University of Central Florida Design, Construction, and Renovation

Standards 2011

September 13, 2011

Changes Made to UCF Design, Construction, and Renovation Standards

Insertion: Drawing

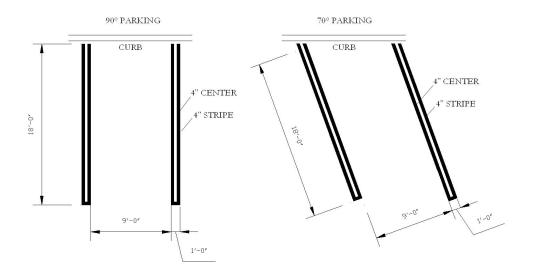
Deletion: Drawing
